BEN LOMAND MOUNTAIN VILLAGE

OVERALL GRADING

12 OF 23

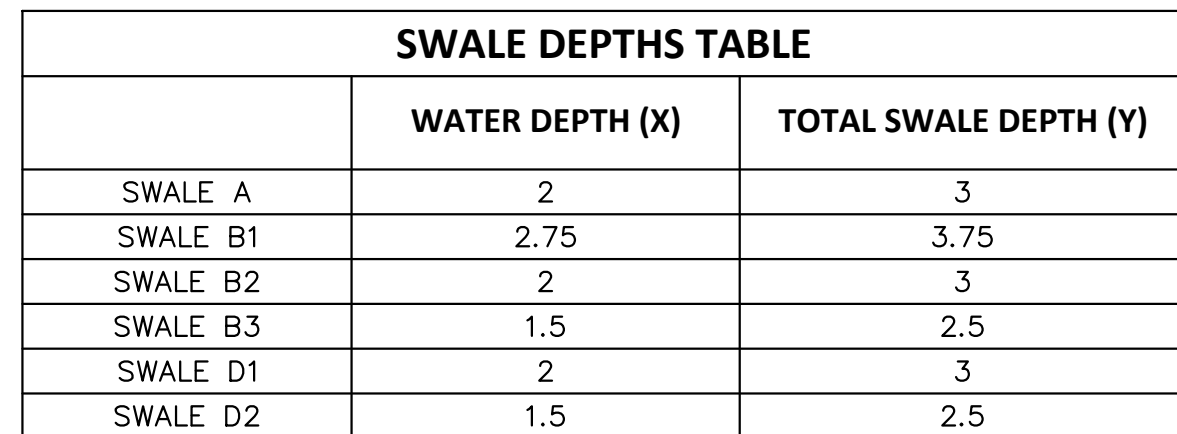
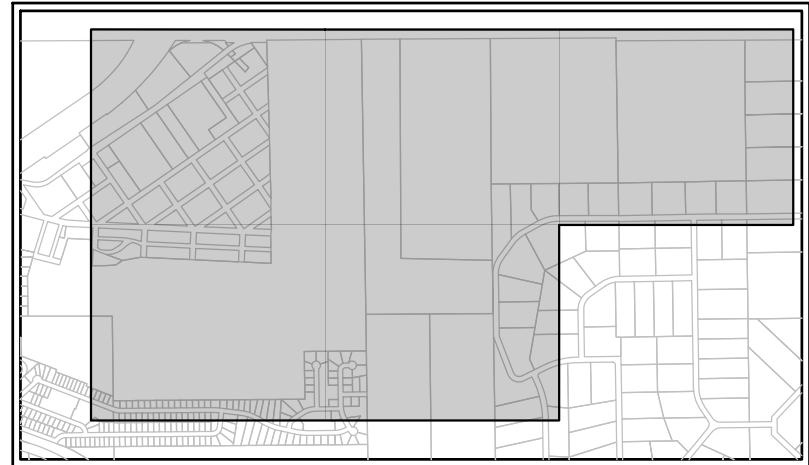
The Geotech reported groundwater as shallow as 2 ft below the ground surface. These ponds appear to be in cut. How will groundwater be mitigated? Groundwater levels should be at least 3 ft below pond bottom to go unmitigated.
